**NELSON GEOTECHNICAL
ASSOCIATES. INC.**

MEMORANDUM

RE: Intrachat Hoang Residence
7929 East Mercer Way
Mercer Island, Washington
NGA File No. 1276521

Geotechnical Peer Review Comment Response

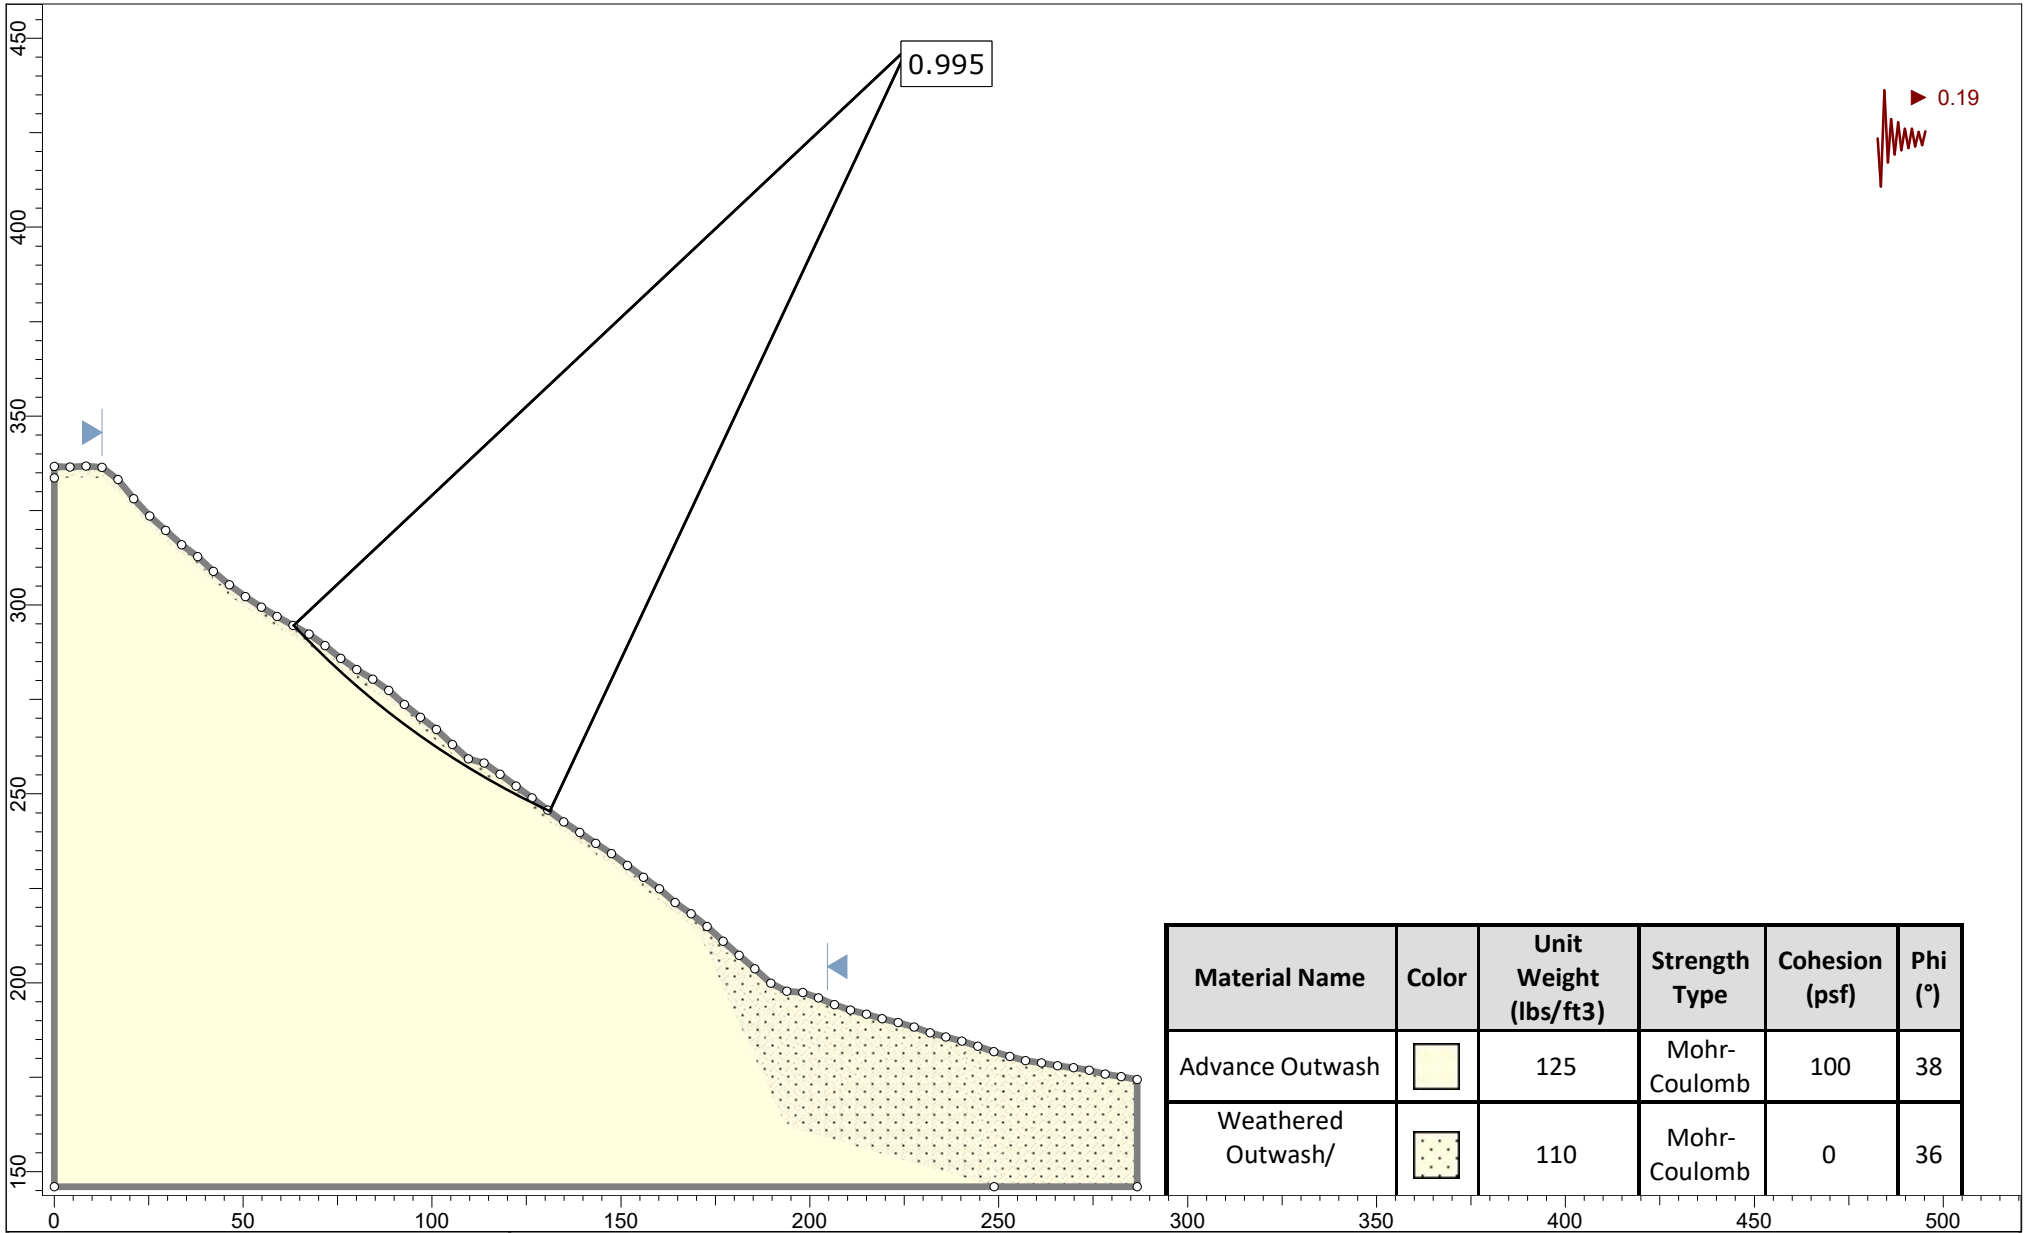
Comment 3: *The NGA response gives the basis of the pseudostatic coefficient, however, please review the calculations since the results do not agree with general discussion presented in NHI 11-032. For example, on NHI page 6-8, "Values of β less than 1.0 in Equation 6-3 and in Figure 6-3 would be typically associated with seismic conditions in the eastern United States, firm ground conditions, and lower acceleration levels, while values of β greater than 1.0 would be associated with the Western U.S., higher accelerations, and Site Class C or D site conditions." Beta value used by NGA is 0.734.*

NHI Figure 6-3 indicates that the scaling factor, alpha, should be at least 0.5 for a beta value of 1 and slope height of 100 feet. NGA indicates an alpha value of 0.367.

Please review and revise submitted calculations and revise stability analyses to reflect revised pseudostatic coefficient. Provide results in report addendum.

Response 3: The calculations were revised and attached to this document as Figure 3. Accordingly, the pseudostatic coefficient of horizontal ground motion selected for the slope stability analyses is 0.19g. A revised slope stability analysis was provided utilizing Slide2 by Rocscience and resulted in very similar results with respect to size and shape of slide and with a factor of safety for sliding of 0.995. The revised slope stability analysis is provided in Figure 1.

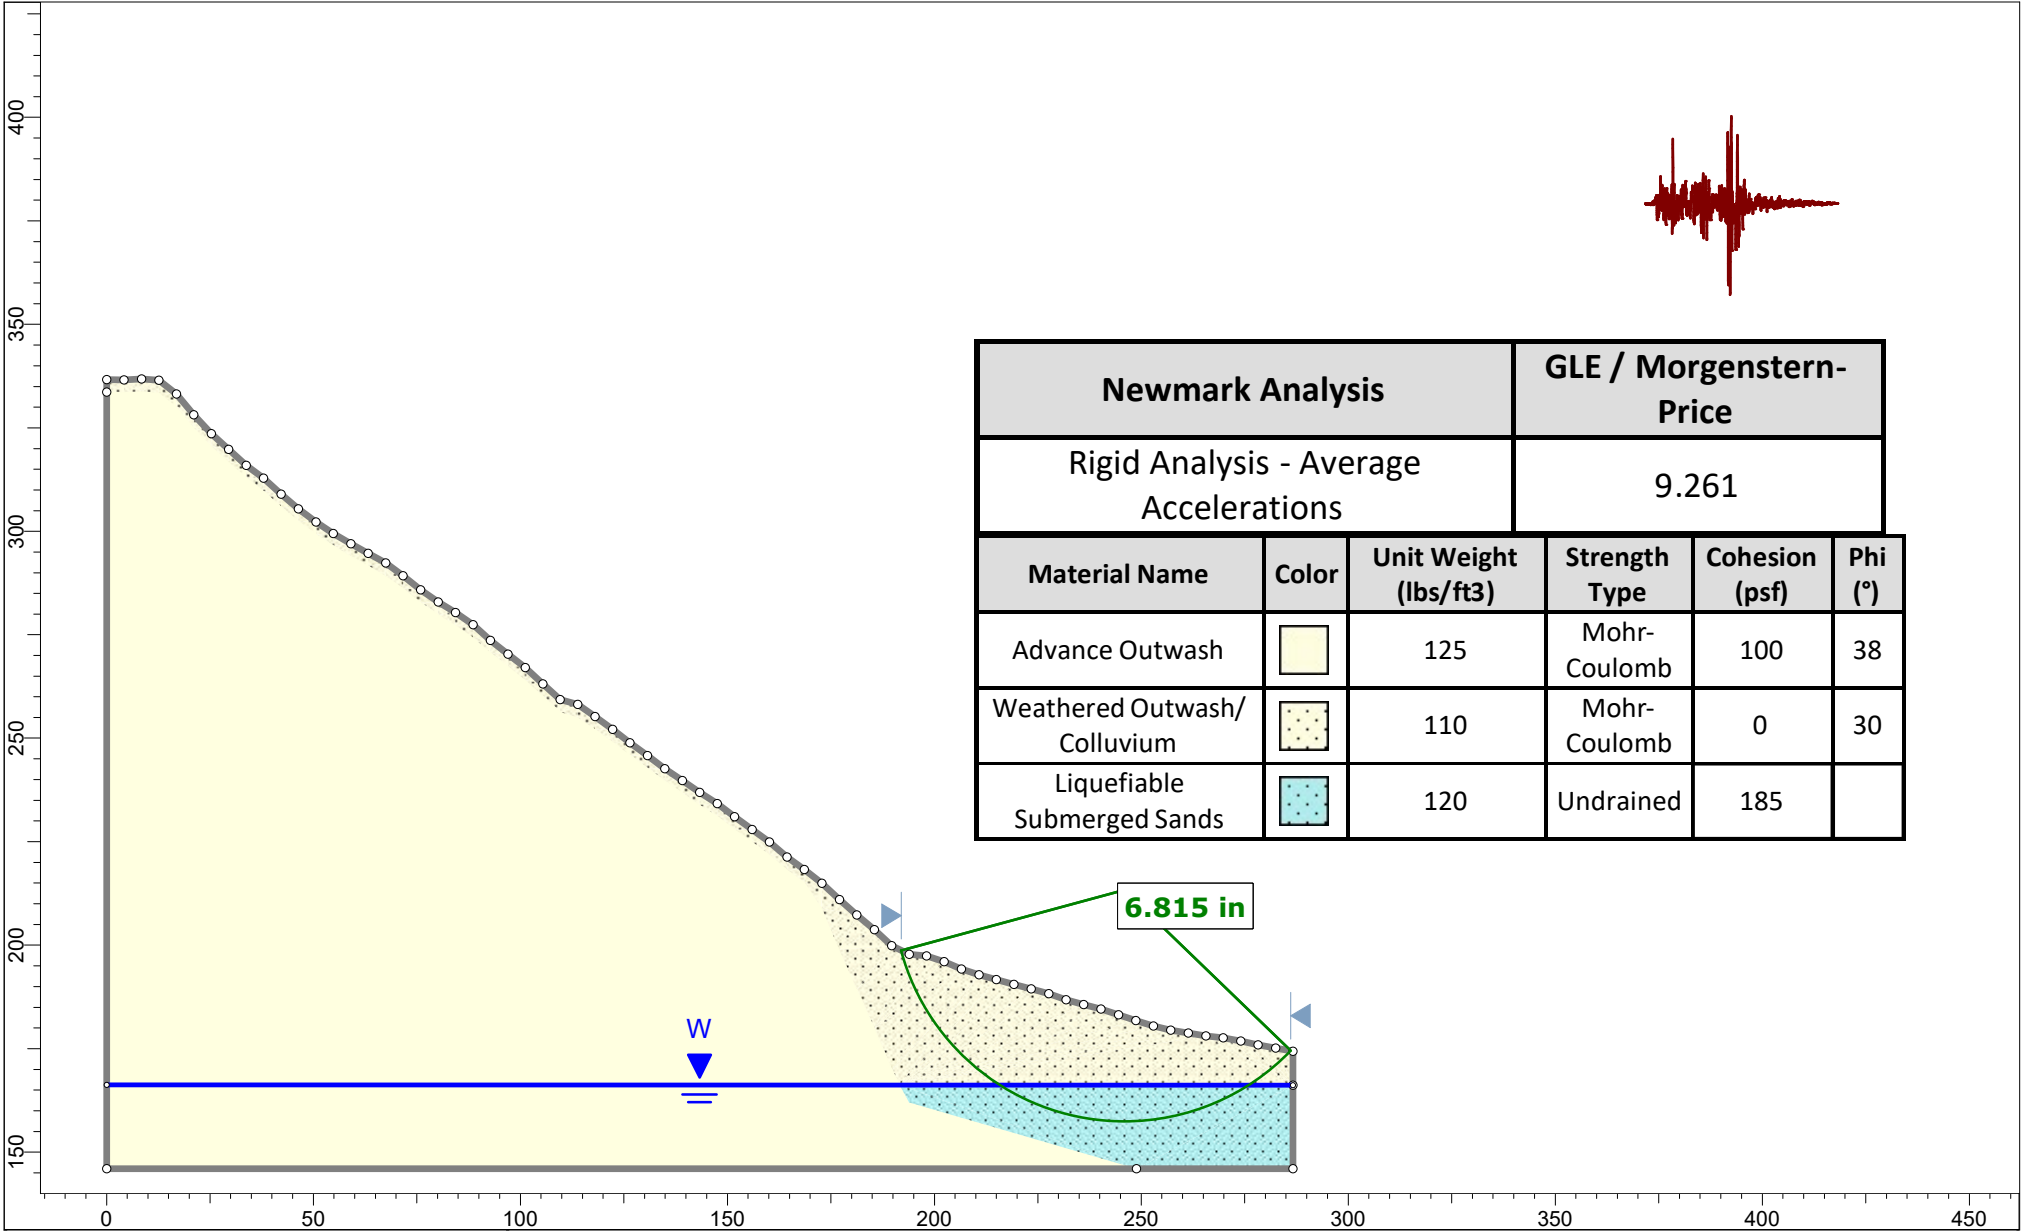
Comment 2: *IBC requires an assessment of potential consequences of liquefaction. Lateral soil movement is one of the potential consequences.*

With residual strength values assigned to liquefied soils, even gently sloping terrain could be subject to flow failures or lateral spreading. The potential impact to the proposed residence as well as adjacent properties is required in order to support the statement of risk (MICC 19.07.160.B.3) required for approval of the building permit.

Please provide basis for the residual strengths used in slope stability analyses to identify potential post-liquefaction lateral spreading or flow failures. Please provide stability cross section showing results and supporting calculations for the estimated soil deformations in a report addendum.

Response 2: Guidance on selection of residual strength values for soils expected to be liquefaction susceptible were provided by the USGS Technical Report titled "Probabilistic Residual Shear Strength Criteria for Post-Liquefaction Evaluation of Cohesionless Soil Deposits." The research and discussion in this report indicates the available liquefied shear strength values for cohesionless soil deposits can be correlated to the minimum standard penetration test N-value. Utilizing the equation provided for average liquefied shear strength and a minimum corrected N-value obtained from the previous drilling, we determined shear strength value to be approximately 185 psf. As such, an undrained shear strength model was defined for the granular deposits below the groundwater table and the above value input. The water table was elevated by approximately 4-feet from the observed elevation in the modeling to reflect potential rise during seismic loading. The relatively loose granular deposits encountered above the groundwater table were assigned a 30-degree friction angle with no cohesion based on SPT correlations. The lateral spreading or flow failure potential for this site was modeled in the limit equilibrium slope stability software Slide2 by Rocscience, as shown in Figure 2. Because of the relatively high peak ground acceleration for this site, a Newmark Displacement Analysis was utilized to assess the expected downslope deformation in the event of such a seismic scenario for better risk management. A seismic record scenario

was input into the program to run this analysis and consisted of the Nahanni, Canada 1985 earthquake which defines a peak ground acceleration of 0.978g. As such, a scaling factor was applied to the analysis to adjust for site conditions. The analysis computes the cumulative earth displacement in the downslope direction for all seismic accelerations during the seismic record that cause the slope stability to fall below a factor of safety of 1. The results indicated approximately 6.815 inches of total displacement, which is considered tolerable given the deep foundation support and unlikely nature of such an event. The probability of this magnitude of failure was assessed by the above mentioned USGS technical report by using equation 4-15 which considers the N-value correlated liquefied shear strength of the soils and the flow failure demand, which is equivalent to the cyclic stress ratio (CSR). The average CSR along the liquefiable soil profile shown on the revised liquefaction analysis (Plate A-1) was determined by the software as 0.52. With these values we computed a probability of flow failure of less than 1 percent.
